APPLICATION FOR CERTIFICATION FOR THE
TID ALMOND 2 POWER PLANT PROJECT

DOCKET No. 09-AFC-2

ERRATA TO THE PRESIDING MEMBER'S PROPOSED DECISION

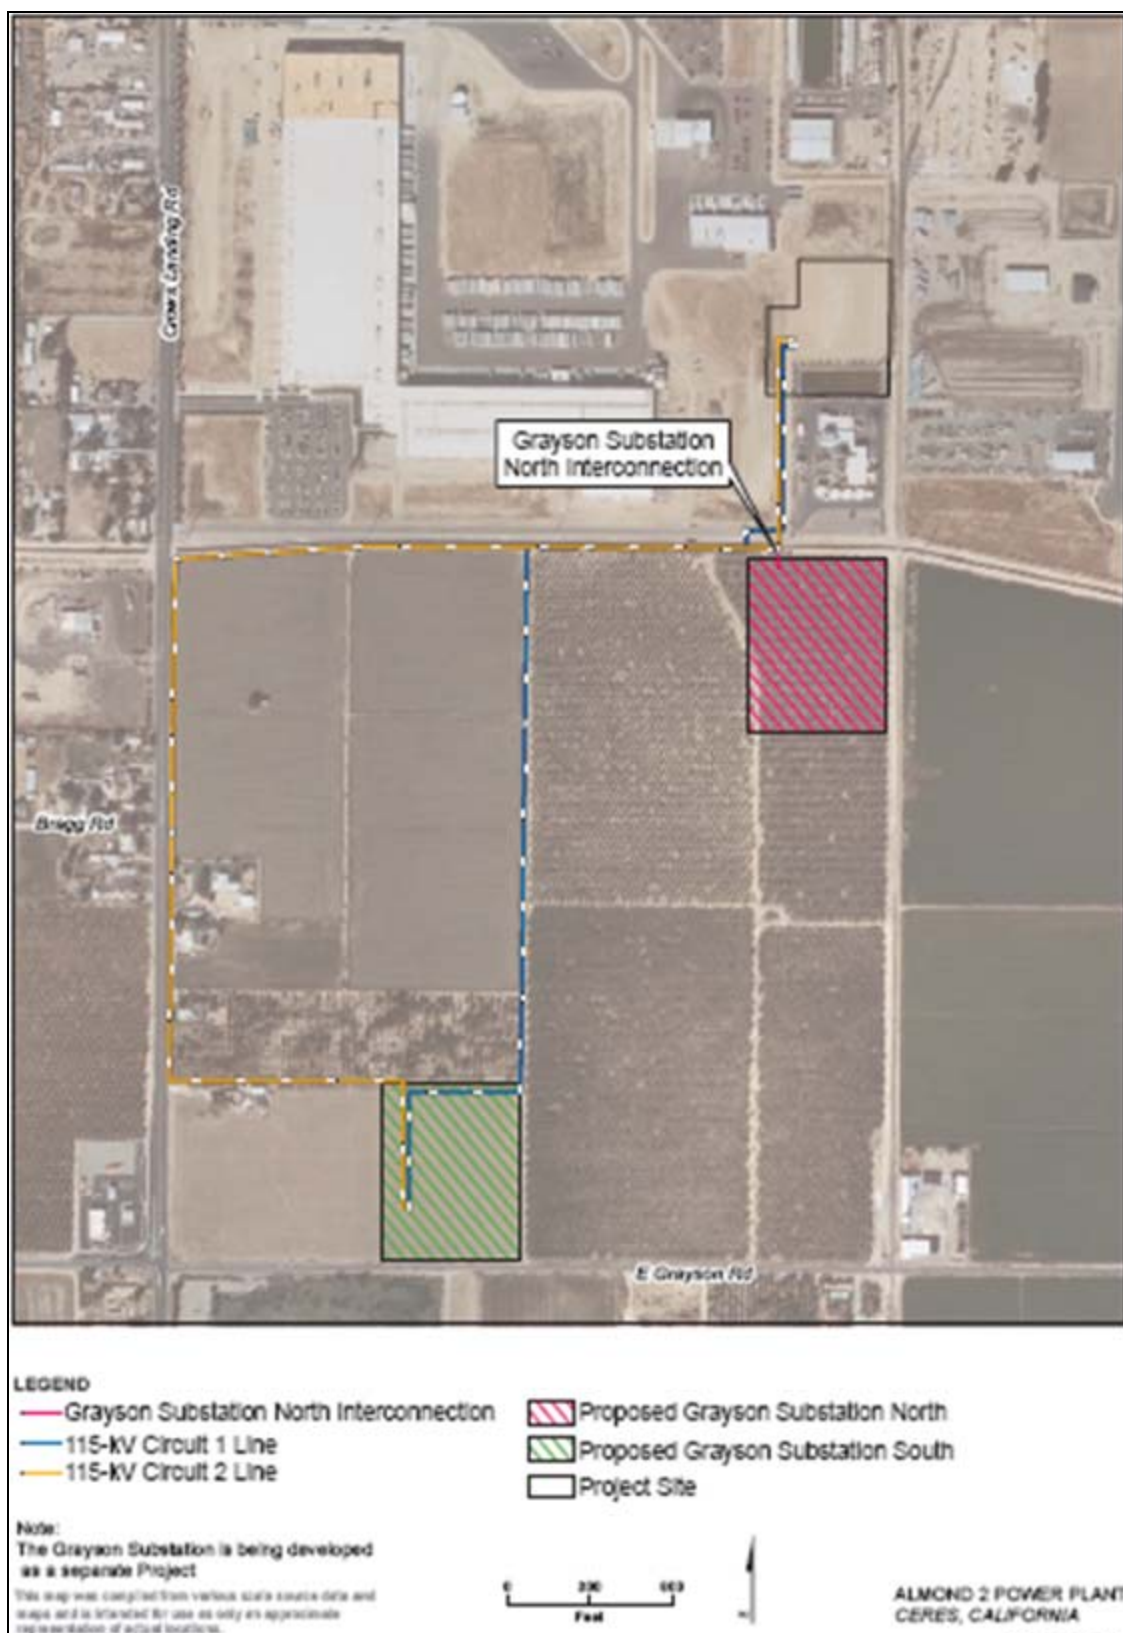
Two alternative locations were proposed for the Grayson Substation: Grayson Substation South and Grayson Substation North. (See **Introduction Figure 1** below, Exs. 42, p. 1-3 [Figure 1.1-1], 46.) Grayson Substation South would require the two 115-kV lines identified in the Application for Certification and revised Staff Assessment as Corridor 1 and Corridor 2. Under the Grayson Substation North alternative, Corridor 1 would be eliminated and instead, only a single 115-kV line in modified Corridor 2 would be required. (Exs. 42, 46.) The modified Corridor 2 would be significantly shorter than Corridor 2 as initially proposed, would extend 30 feet beyond TID's Lateral No 2 (a canal), and would require transmission poles up to a height of 130 feet (the poles as initially

During the 30-day PMPD comment period, the Applicant informed the Committee that the TID Board of Directors, as part of its approval of the TID's Hughson-Grayson Substation Project on November 2, 2002, selected the Grayson Substation North alternative for the connection of the A2PP to the grid. That alternative eliminates Corridor 1 and requires a modified Corridor 2 as described above. (See Introduction Figure 1). While we recognize the the transmission line modifications required for implementation of the Grayson Substation North alternative, we find that the PMPD does not require modification as it and the underlying evidence assess the transmission line-related impacts that might arise from implementation of the the Grayson Substation North alternative.

Figure 1.1-3 R – Visual and Land Use

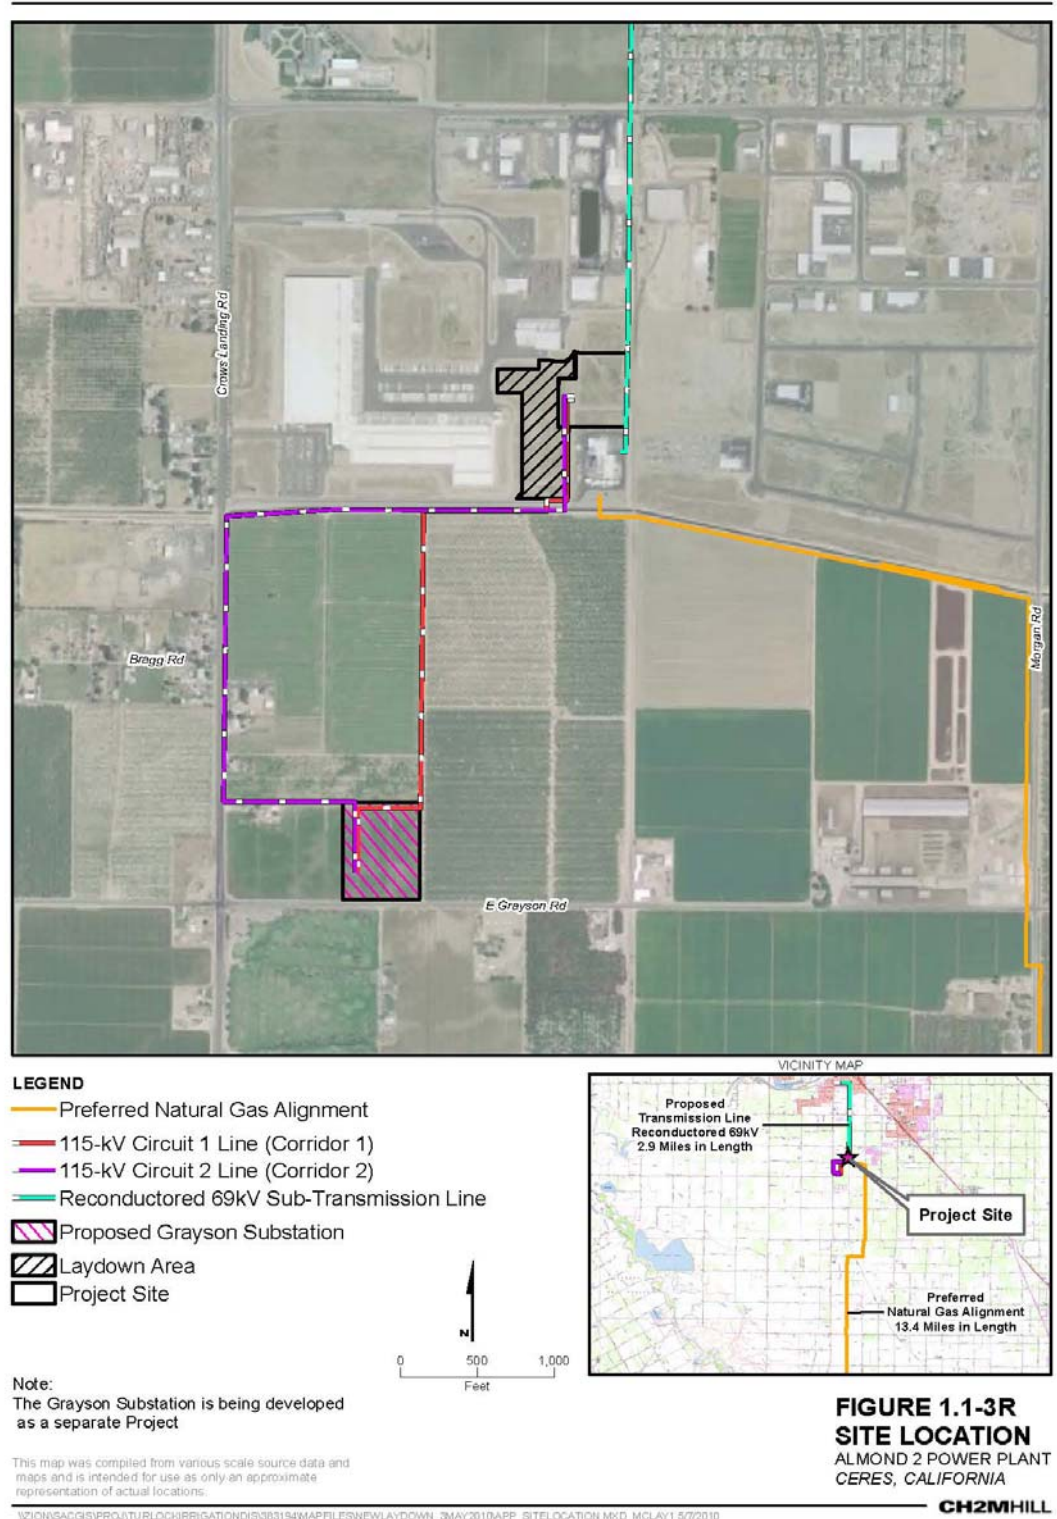
59. Page 7, Figure 1:

77. Page 5, Figure 1, add footnote to read as follows:

Replace Figure 1 with the attached map.

The correct location of the lay down area is shown in Land Use Figure 1.
(Attached.)
